**SUBJECT: TRAFFIC METHODOLOGY APPROVAL LETTER**  
PROJECT NAME: ENCLAVE HOUSING CR 42 TRAFFIC IMPACT STUDY  
PROJECT #2025010062 APPLICATION: #32409 PARCEL #47667-004-00

Project: Enclave Housing CR 42

Subject: Proposed Methodology for Enclave Housing CR 42

RE: Enclave Housing CR 42 Response to Comments

*SITE DATA*

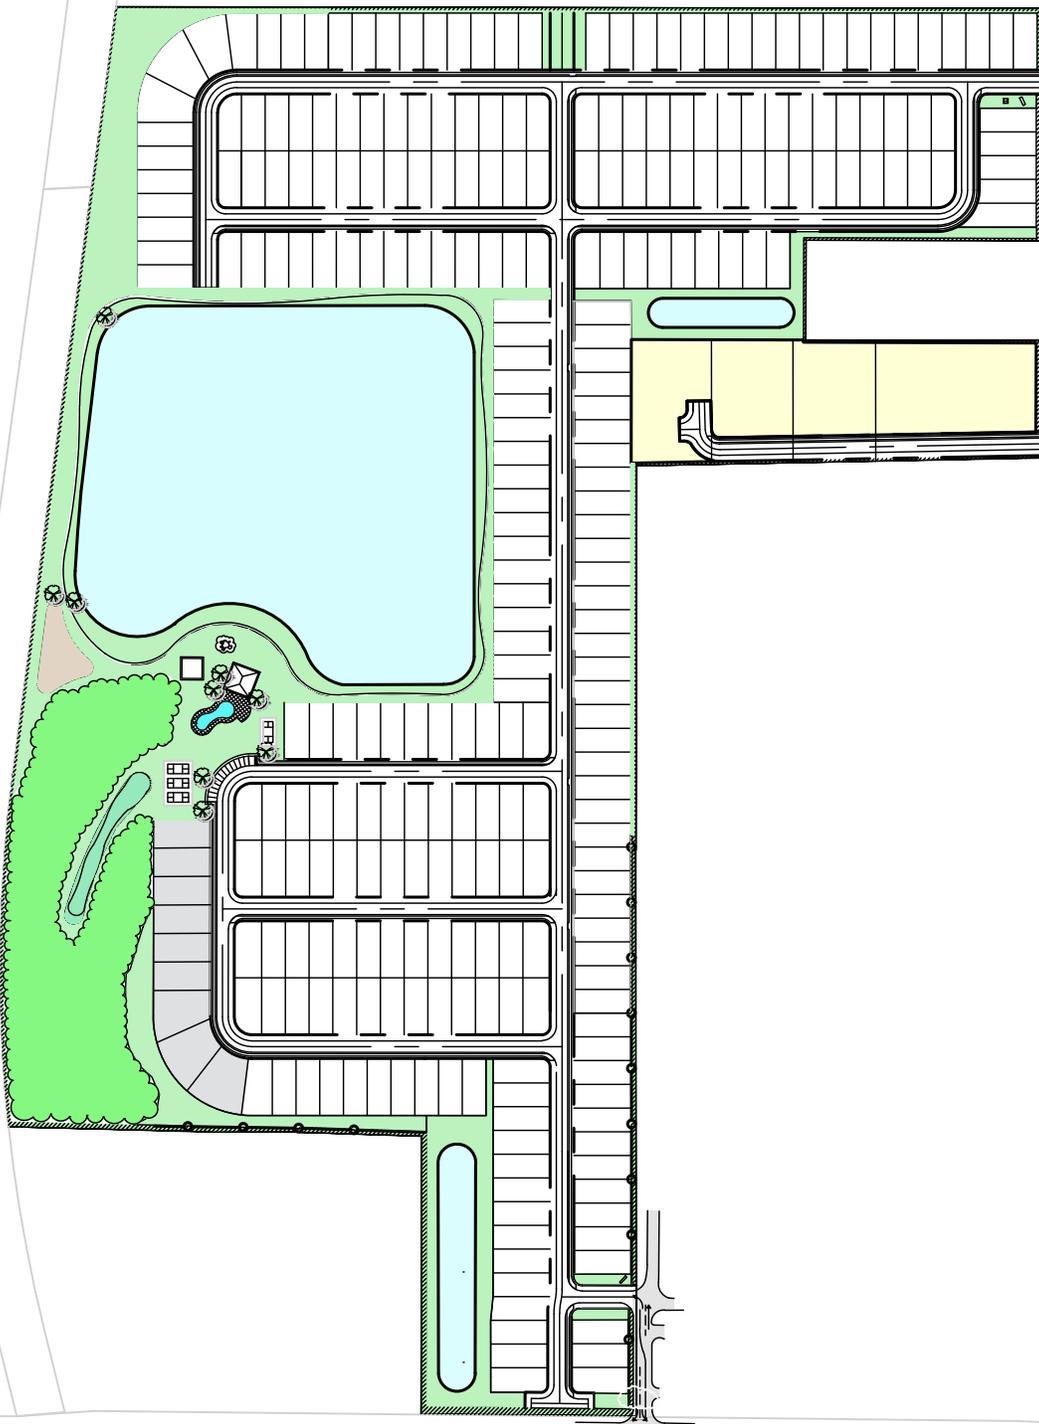
6. PDF pg. 12 & 13 - The site data shows the number of units proposed but does not show the proposed access locations. Provide an updated concept plan showing the proposed access locations on CR 42 and SE 73rd Ave.

***Response: The concept plan showing the access locations is attached to the revised methodology.***
